THE BABCOCK & WILCOX COMPANY POWER GENERATION GROUP		CONFIDENTIAL COUNSEL ONLY	TLC TERRY Chuck FRED.
To	W. H. Spangler, Nuclear Service		
From	E. W. Swanson, Plant Integration		803 653.5
Cust.	Toledo-MSS-14	File No. or Ref.	
Subj.	Auxiliary Feedwater Setpoints	Date	November 15, 1978

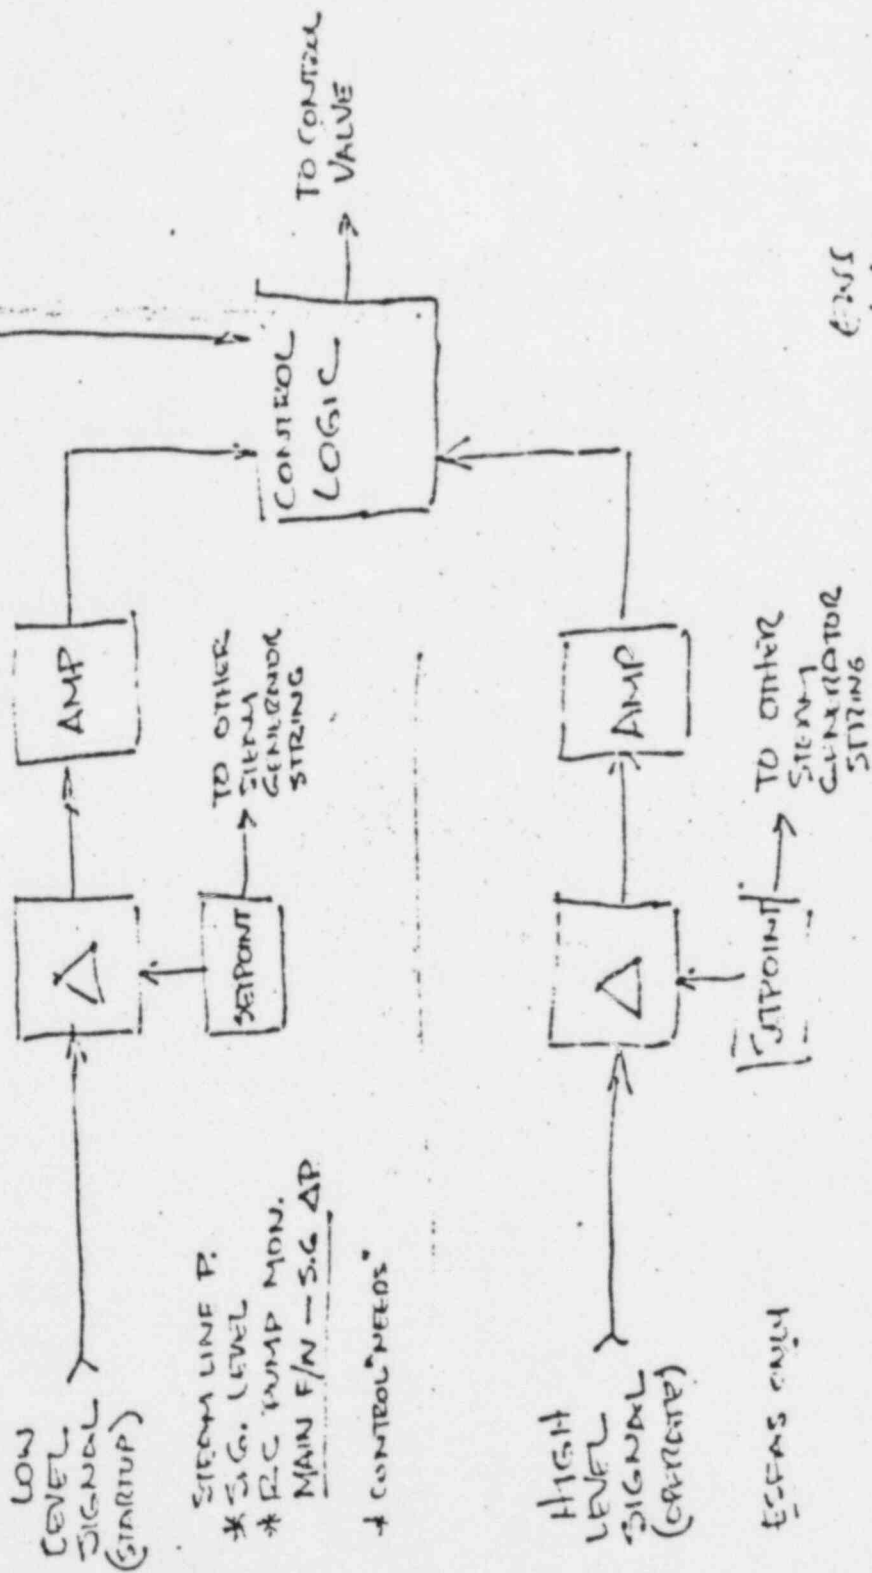
ESFAS/SFRAB MOD. IS PROBABLY
THE BEST FIX IN THAT FIELD
CHANGES WOULD BE LESS EXPENSIVE &
IMPACT ON ECCS WOULD BE
OF LESS RISE. THAT IS, ONE WOULD
AT LEAST GET A 10-FT LEVEL DURING
POST LOCA CONDITIONS. → IS A LEVEL
CONTROL FOLLOWING ESFAS ACTUATION
MANDATORY? LLC

ESFAS
↓
AFW ACT.
↓
NO LEVEL
CONTROL
↓
OPERATOR
MUST INTERVENE
TO TERMINATE
AFW FLOW.
